Our Ref: - 1226-01 – Collyhurst Village

Planning Ref: 129393/VO/2021

Collyhurst Village - SuDS Strategy Note

Figure 2: Plot B approved layout

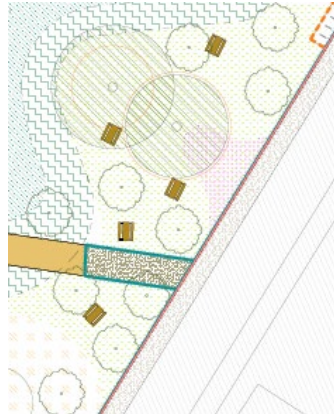
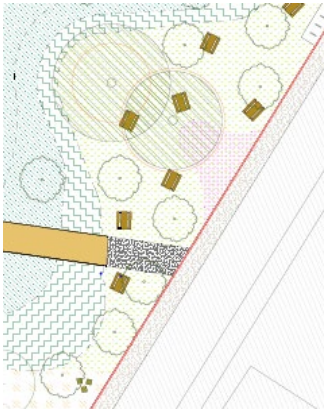
To enable adoption of the tertiary street within plot B, the carriageway is proposed to be widened to 5.5m with the proposed soft verge amended to a 2m footpath. The soft verge performs as a raingarden and therefore it has been relocated so that the SuDS functionality remains in accordance with the planning permission.

The raingarden is proposed to be relocated within the carriageway adjacent to the approved location. See below Figure 3 which indicates the proposed location. Due to site constraints (proposed building location and adoptable road widths) the proposed raingarden has been reduced in size, however, it still performs the same function and will drain highway run-off in accordance with the planning permission.

As a result of the above, 3no trees will be relocated, within Plot B. 2no trees will be relocated on the adjoining roads (please see Figures 2 and 3 below) and 1no tree proposed will be relocated within the park (please see Figures 4 and 5 below).

Figure 6: Plot D Approved layout

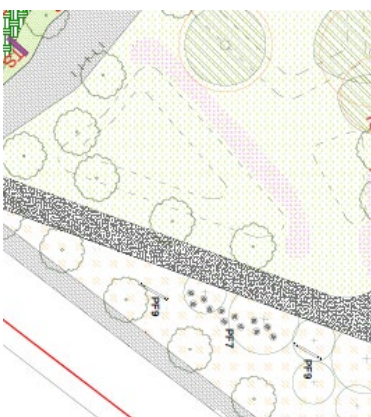
To enable adoption of the tertiary street within plot D, it is proposed that the carriageway is widened to 5.5m with the proposed soft verge amended to a 2m footpath. The soft verge performs as a raingarden and therefore it has been relocated so that the SuDS functionality remains in accordance with the planning permission.

The raingarden is proposed to be relocated within the carriageway adjacent to the approved location. See below Figure 7 which indicates the proposed location. Due to site constraints (proposed building location and adoptable road widths) the proposed raingarden has been reduced in size, however, it still performs the same function and will drain highway run-off in accordance with the planning permission.

As a result of the above, 1no number trees is proposed to be relocated from Plot D (please see Figures 6 and 7 below) to the park (please see figures 8 and 9 below).
